City of Corpus Christi

Planning Commission

Wednesday, April 6, 2022

**TECHNICAL REVIEW PLAT REQUIREMENTS
REGULAR PLANNING COMMISSION MEETING
April 6, 2022**

SHEET 2 OF 2

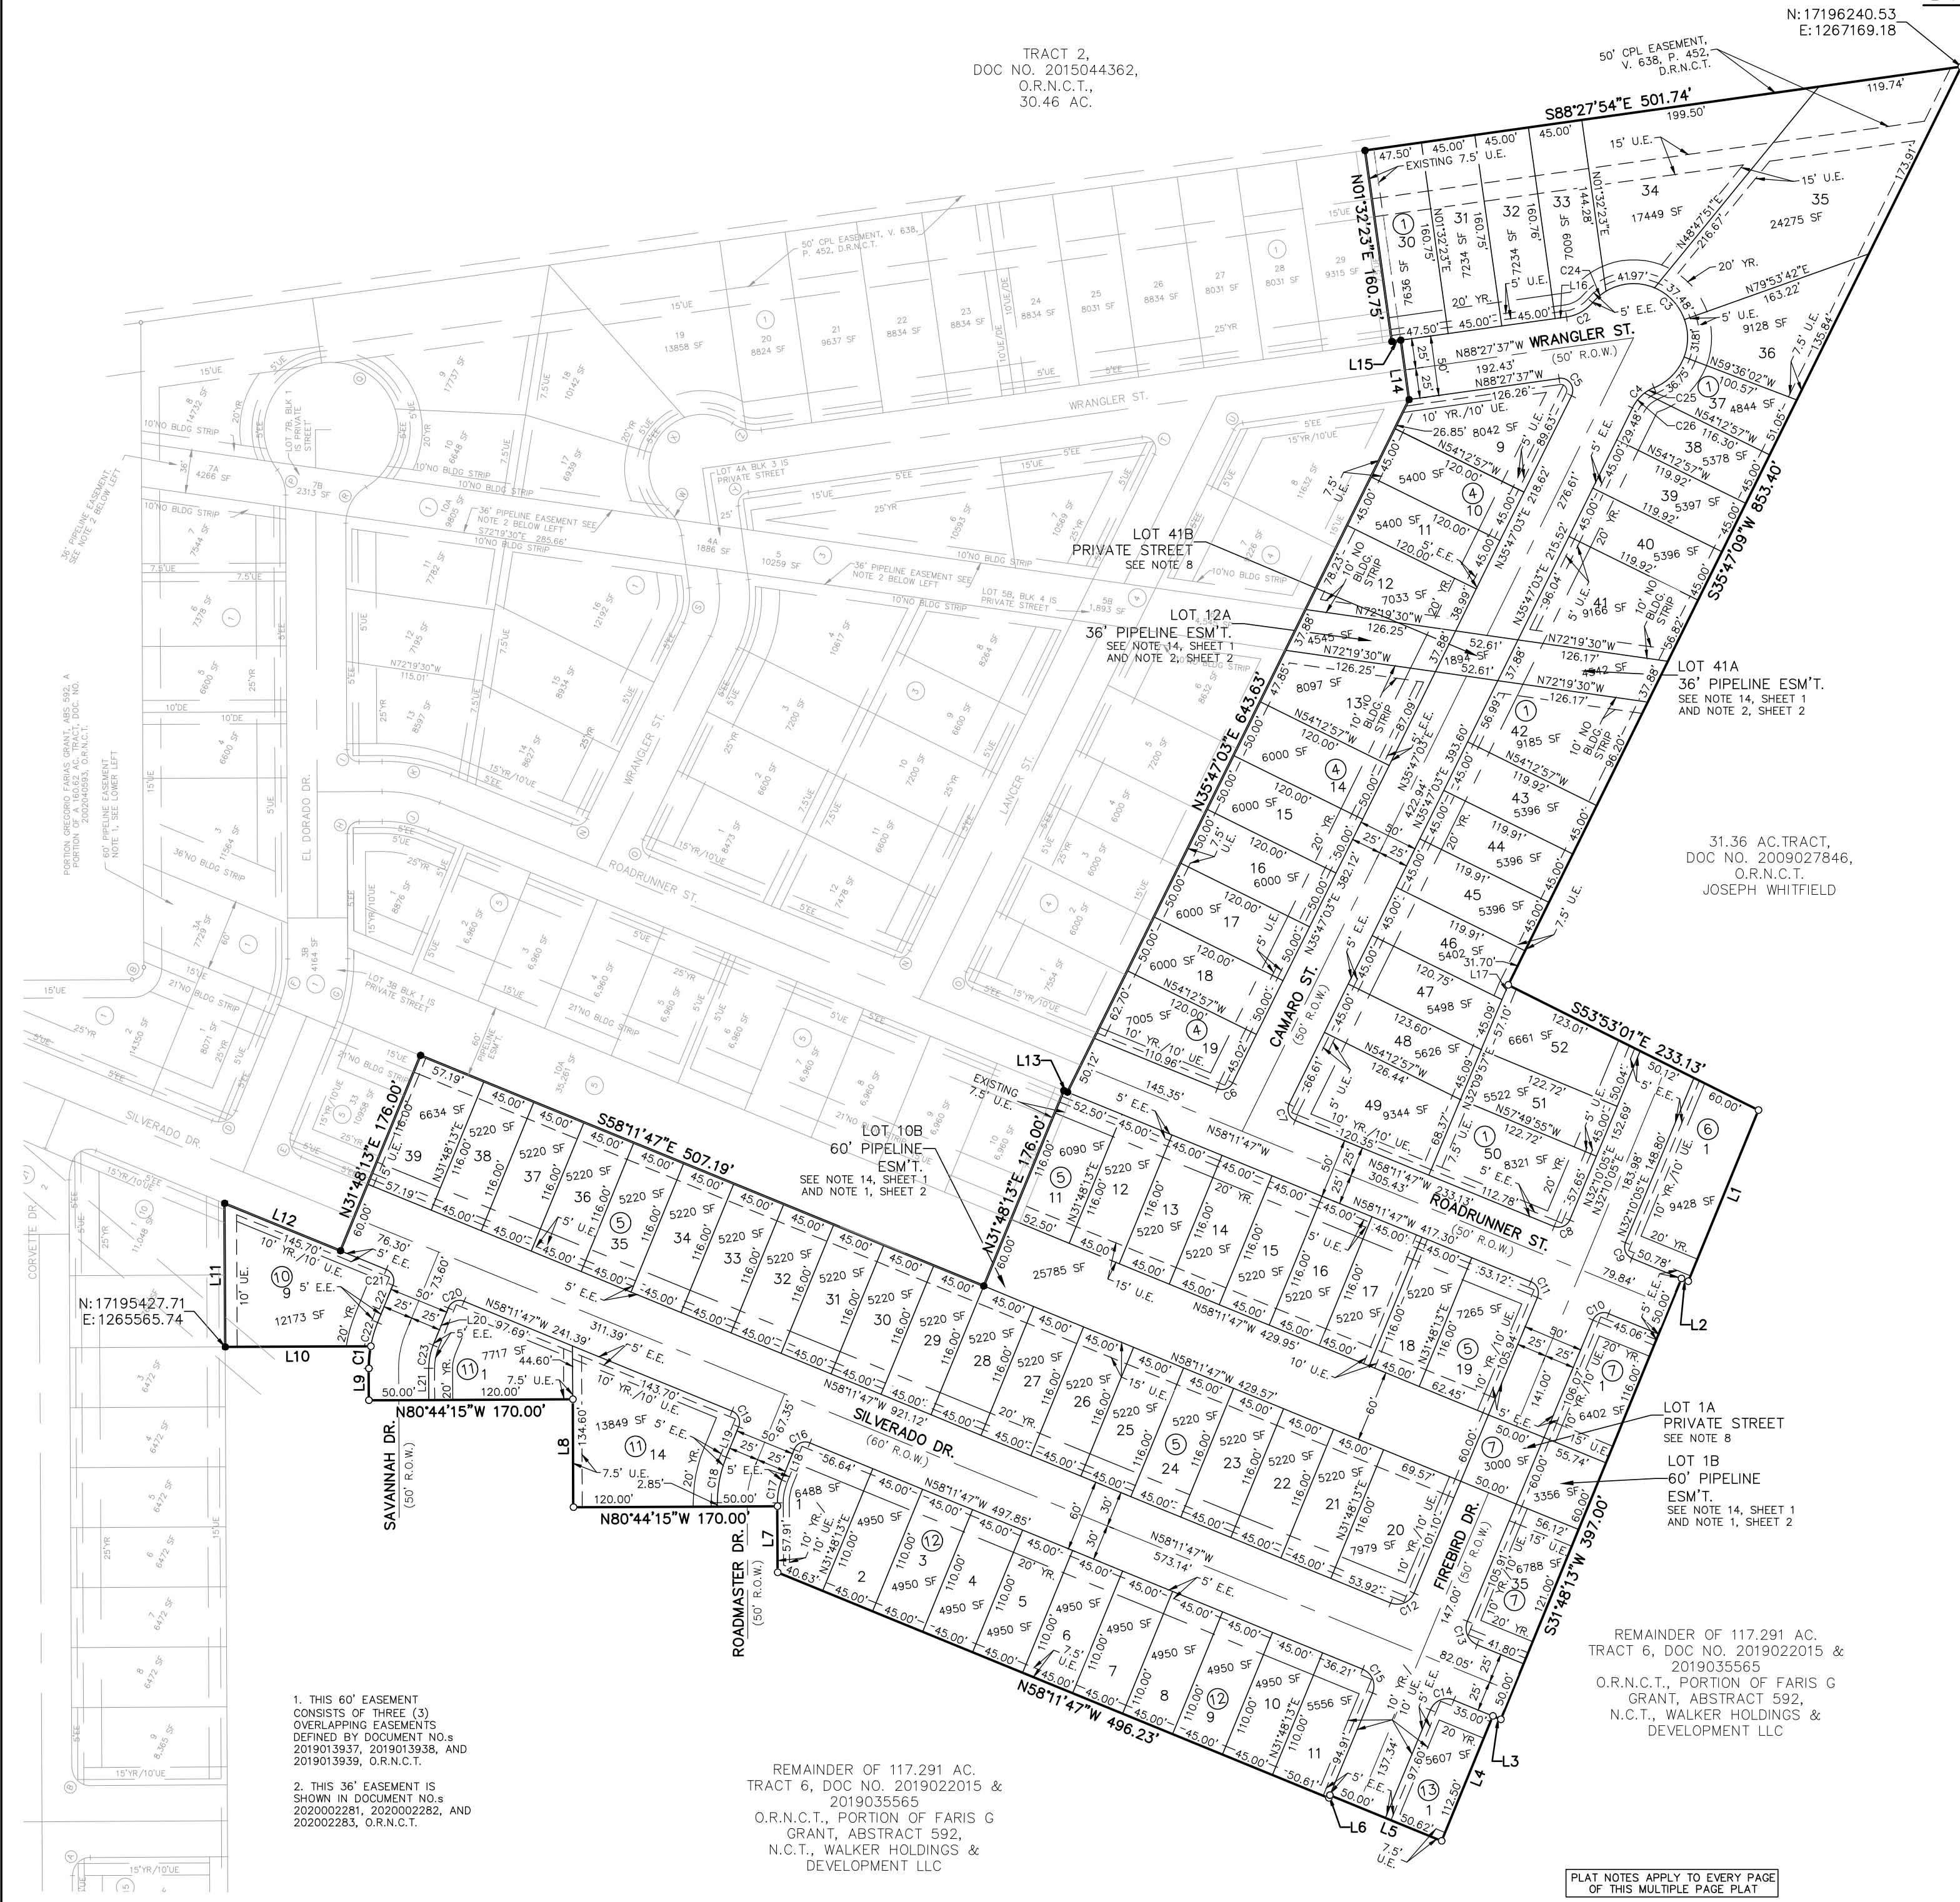
3	Plat	Ensure all block numbers are correct for platted area (block 6 lot 20). Labeling blocks with circled number is preferred.	Comment acknowledged. Block numbers are now circled in spaced out lots.	Addressed.		
4	Plat	Future unrecorded subdivisions are not accurate legal descriptions of the adjacent properties.	Understood	Addressed.

6	Plat	Provide copy of HOA to Development Services.	Will provide once HOA documentation is available.	To be addressed prior to recordation.		
7	Plat	To address the infrastructure crossing in the Private street. Update on Plat note 8 to "Private street and Easement" .	Plat note 8 updated.	Addressed.		
8	Plat	DS Engineer is Brett Flint, PE.	DS Engineer name updated.	Addressed.		
9	Plat	PC Chairman is Jeremy Baugh and Secretary is Al Raymond III, AIA	PC Chairman and Secretary name updated.	Addressed.		
10	Plat	Provide square footages for all lots on a table or within lot area.	Sqaure footage for all lots provided.	Addressed.		
11	Plat	Label 5' EE on Lot 16, Blk 8; on Lot 34, Blk 14; on Lot 1, Blk 14	Comment acknowledged. 5' EE is labeled.	Addressed.		
12	Plat	Verify Block 14 boundaries.	Block 14 boundaries verified.	Addressed.

13	Plat	Recommend providing an easement at rear of Block 6 and 14.	Easement has been added to the rear of Block 6 and 14.	Addressed.		
14	Plat	Verify right of way width of Silverado Drive (label) and dimensions. Unit 1 Silverado Drive is a 60 ft ROW. Verify with Silverado Drive east of Emory Drive.	Comment acknowledged. Verified with preliminary plat.	Addressed.		
15	Plat	Water Distribution System lot fee – 72 lots x \$200.20/lot = \$14,415.71	Fees will be paid before recordation	To be addressed prior to recordation.		
16	Plat	Wastewater System lot fee –721 lots x \$432.30/lot = \$31,125.60	Fees will be paid before recordation	To be addressed prior to recordation.		
17	Plat	Provide document for Pipeline Easement.	Comment acknowledged and provided.	Addressed.		
18	Plat	Prior to recordation coordinate with AEP on street light fees and provided confirmation of payment.	Comment acknowledged. Coordination with AEP and confirmation will be provided.	To be addressed prior to recordation.

TRAFFIC ENGINEERING						
No.	Sheet	Comment	Applicant Response	Staff Resolution	Applicant Response	Staff Resolution
1	Plat:	Silverado Dr shows a dead end without a permanent or temporary cul-de-sac. Solid Waste vehicles need to turn around using a cul-de-sac in order to service lot 42. Need to revise design in this area to address this comment.	Preliminary plat was approved with this street layout. A no outlet sign was added to street intersections with dead end streets.	Separate Temporary right of way easement to recorded prior to plat recording		
2	Infor:	Driveways on Texas Department of Transportation (TxDOT) maintained roadways shall conform to TxDOT Design criteria and shall be permitted by TxDOT.	Understood	Addressed.		
3	Informa tional:	Proposed driveway access to a public City Street shall conform to access management standards outlined in Article 7 of the UDC (UDC 7.1.7)	Understood	Addressed.

13	Plat	Table D103.4 Requirements for Dead-end fire apparatus access roads. Turnaround provisions shall be provided with a 96-foot diameter cul-de-sac.	Preliminary plat was approved with this street layout. A no outlet sign was added to street intersections with dead end streets.	To be addressed with public improvements.		
14	Note	During time of construction, roads that form a dead-end shall have temporary turn-arounds until such time as the road is completed.	Comment acknowledged.	To be addressed with public improvements.		
15	Note	Turning radius for fire apparatus should not be less than 45 degrees and curb to curb at 36 feet. The "hairpin turn" created at the intersection of Skylark and Buick results in an acute angle that would appear to prevent fire apparatus from completing a turn without having to back up to negotiate the turn.	Skylark and Buick are not included in the unit 3 plat.	To be addressed with public improvements.
